Technical Bulletin

Re: ACON and Decoder Module Keying Modification

Figure 1

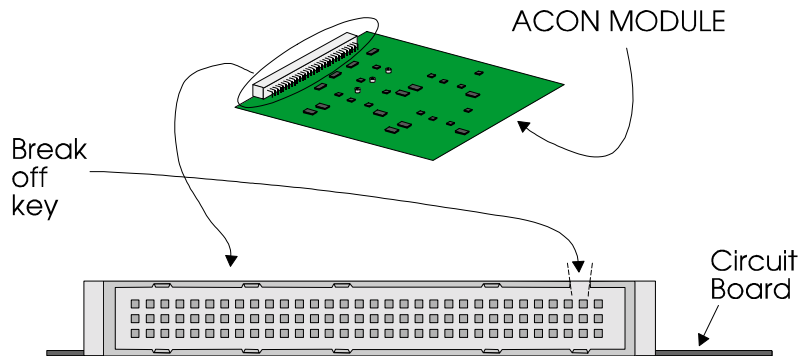
Figure 1 shows how to modify an old ACON module so that it can be used with (inserted into) a new projector. Simply cut out the key-way illustrated. You can use a pair of long nose pliers for best results. More recent ACON modules are shipped with the key-way already removed.

Figure 2

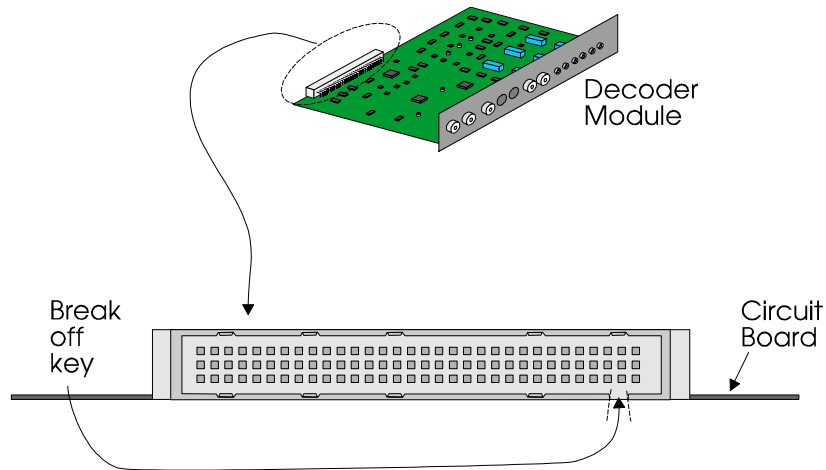
Figure 2 shows how to modify a Decoder Module so that it can be used with (inserted into) a new projector. Simply cut out the key-way illustrated. You can use a pair of long nose pliers for best results. More recent Decoder modules are shipped with the key-way already removed.
